RE: MINOR CHANGE APPLICATION FOR MATERIAL CHANGE OF USE—AGRICULTURAL SUPPLIES STORE, ADVERTISING DEVICE AND DEMOLITION OF BUILDINGS WITHIN THE DESIGNATED STREET FRONTAGE AT 13 LYONS STREET, MUNDUBBERA ON LAND DESCRIBED AS LOT 34 ON SP325437

Amended Decision Notice — ‘Minor’ Change Application

To: Skyring Traffic
Attention: Emma Purdie
From: Dan Sullivan
Date: 10 December 2021
TOPIC: AG-PLUS

Figure 1: Site layout drawing

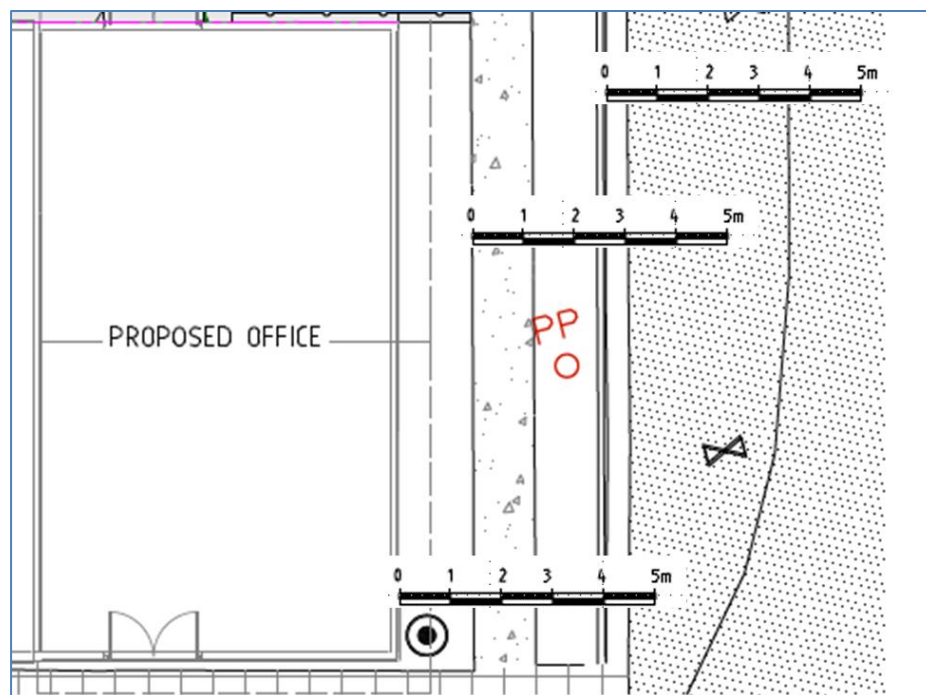
The relevant items of note from this site diagram are as follows;

- Shoulder width on Bauer Street 3.5m
- Verge width including footpath 2.5m
- Building offset from property boundary 1.5m

All of these dimensions are approximate but the accuracy is sufficient for the purpose of this analysis.

Figure 2: Sketch of sight lines around subject site.

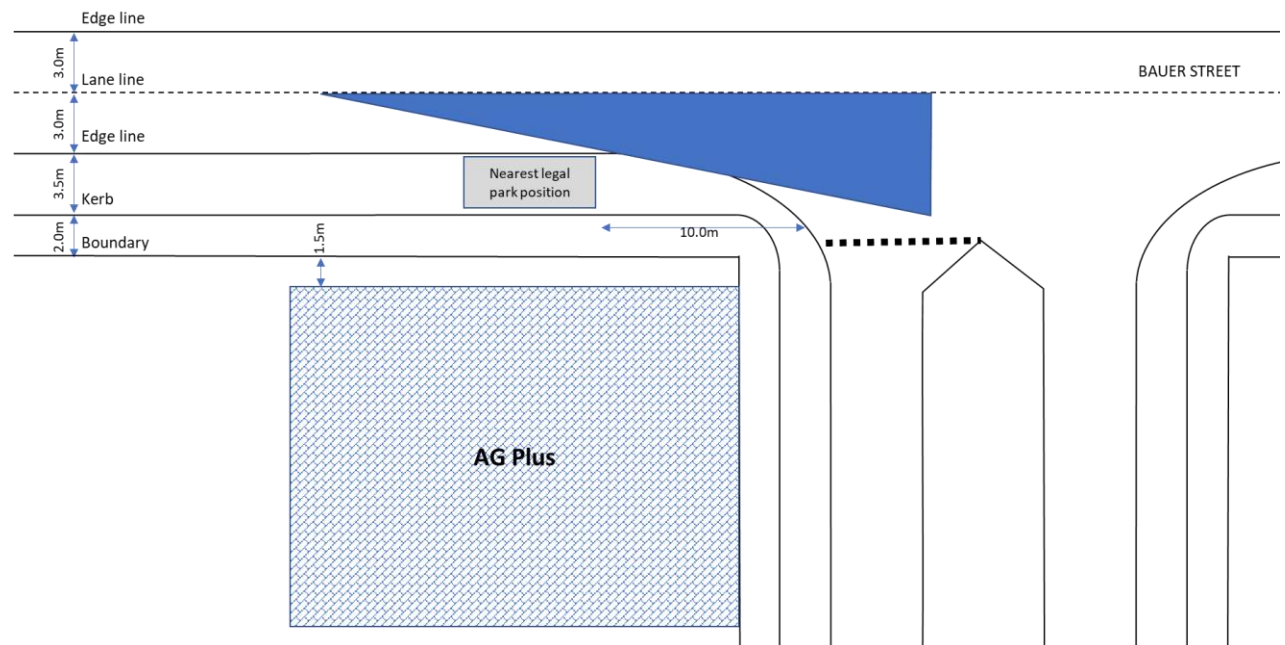
The depiction of the required sight line for vehicles approaching the intersection on Lyons Street is shown with a blue triangle. The key design parameters for estimation of the available sight distance at the intersection are as follows. Note that all parameters have been estimated conservatively to estimate the smallest possible available sight distance.

The corner of the proposed building is set back approximately 7m from the edge of the through traffic lane on Bauer Street, and there is no obstructions as part of the development within 3m of the through traffic lane on Bauer Street. The development therefore does not impact in any way on sight lines which would require a STOP sign to be installed at the intersection.

Even in the worst case scenario of a vehicle parked legally at the edge of Bauer Street at a location 10m from the intersection kerb line and positioned right on the edge line between the shoulder and the lane the calculated dimension Y equals 34m which exceeds the required 30m as detailed in Figure 2.2 from the MUTCD Part 2.

The MUTCD Part 2 states “A STOP sign shall not be used if the sight distance is equal to or greater than shown in Figure 2.2.”. It is therefore concluded that a STOP sign would contradict a mandatory requirement of the MUTCD Part 2. It is therefore recommended that Condition 27 be deleted to remove the requirement for a STOP sign and associated line marking at the intersection of Bauer Street and Lyons Street as a condition of the development.

Figure 3: Traffic volume count – 2 December 2021 2pm-3pm

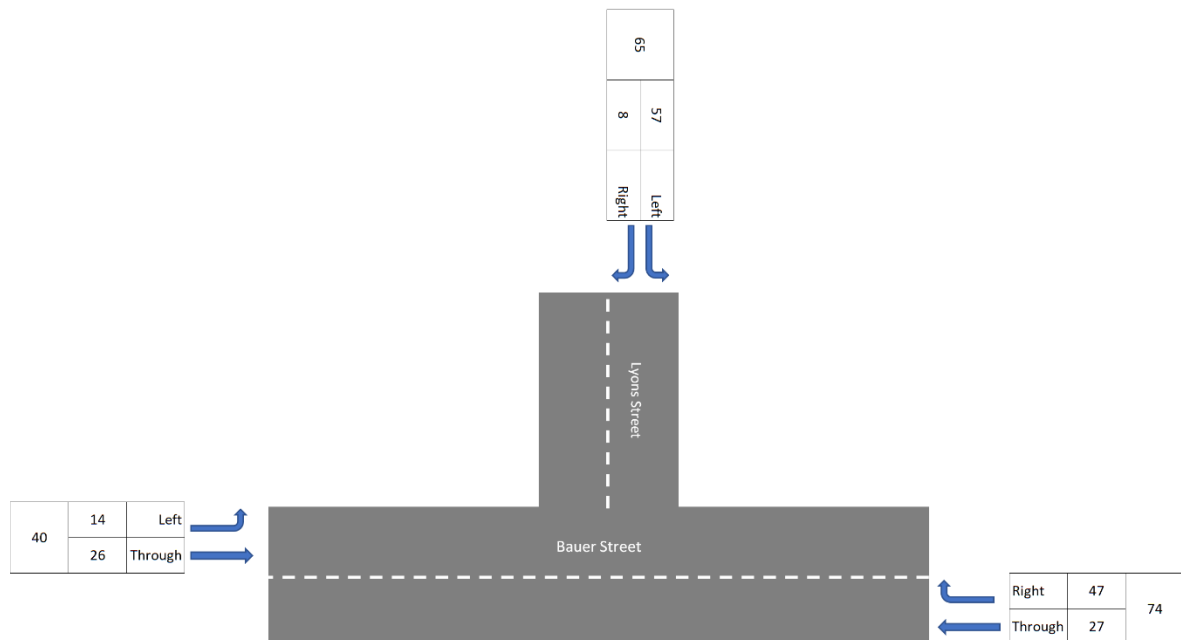
- Traffic volumes
 - A one hour traffic volume count was undertaken on Thursday 2 December 2021 between the hours of 2pm and 3pm. This hour was considered representative of the anticipated delivery vehicle scheduled delivery time. (refer Figure 3)

The traffic management treatment suggested in Condition 25 would require the following elements to be implemented by the development proponent.

The application of the required temporary traffic management devices in accordance with the QGTTM would create a significant level of risk for;

Given that the requirement is to be implemented for a single vehicle movement once per week it is considered that these requirements are manifestly excessive and actually create a higher level of overall safety risk than that mitigated.

MUTCD Part 3 and the QGTTM. To address the residual level of risk associated with delivery vehicles accessing the site it is therefore proposed that the operational procedure detailed at Attachment 2 suitably balances the level of risk exposure for the single weekly vehicle movement.
